MFN 06-265

Docket No. 52-010

Subject: Response to Portion of NRC Request for Additional Information Letter No. 26 Related to ESBWR Design Certification Application – Isolation Condenser - RAI Numbers 5.4-22, 5.4-27, 5.4-31, 5.4-40, 5.4-43, 5.4-47, 5.4-49 and 5.4-51

**Response to Portion of NRC Request for
Additional Information Letter No. 26
Related to ESBWR Design Certification Application
Isolation Condenser
RAI Numbers 5.4-22, 27, 31, 40, 43, 47, 49 and 51**

Figure 5.4-(to be assigned) Isolation Condenser System Simplified Process Diagram

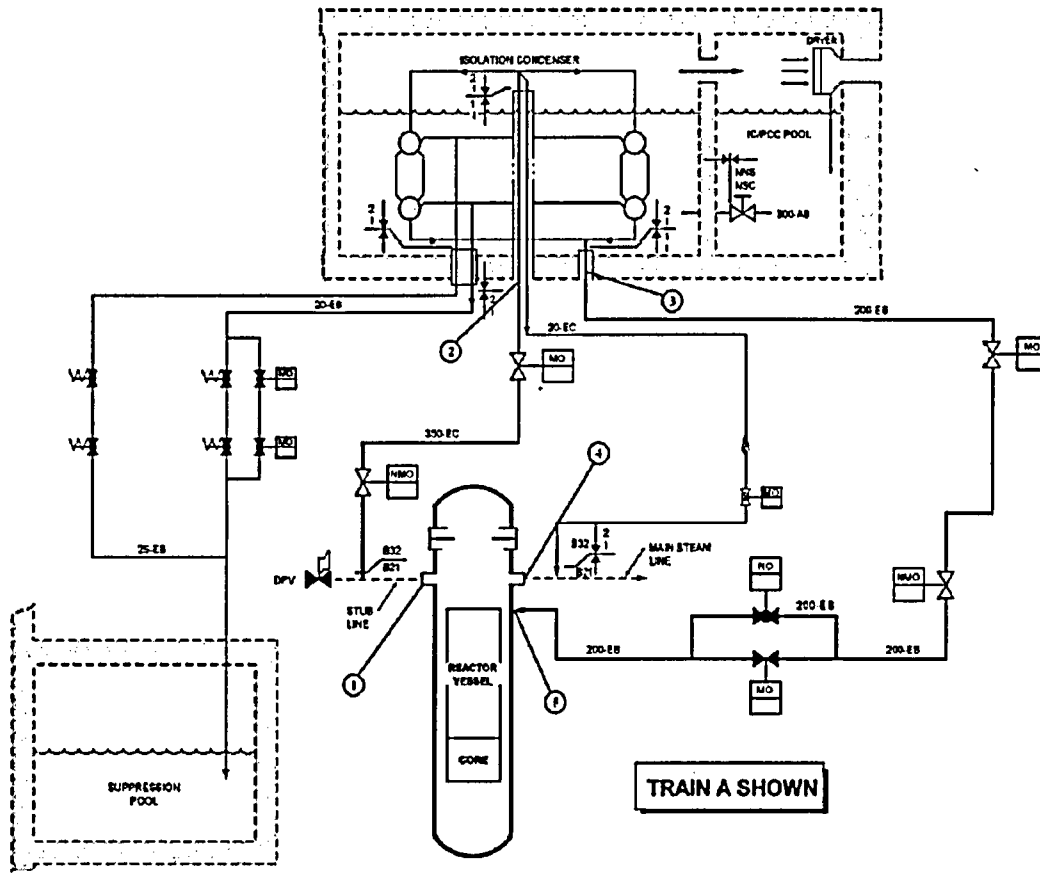
The staff finds the system operation parameters given in Table 5.4-1 is not complete. Provide a diagram showing the ICS design and operating parameters: pressures, temperatures and flow rates. The diagram should be similar to a GE standard Process Flow Diagram (PFD) for the ICS.

A simplified Isolation Condenser System (ICS) process flow diagram (PFD) is provided in the following figure. DCD Tier 2 Section 5.4 will be revised in the next update to incorporate this figure. The requested design data, associated with the figure, follows the figure.
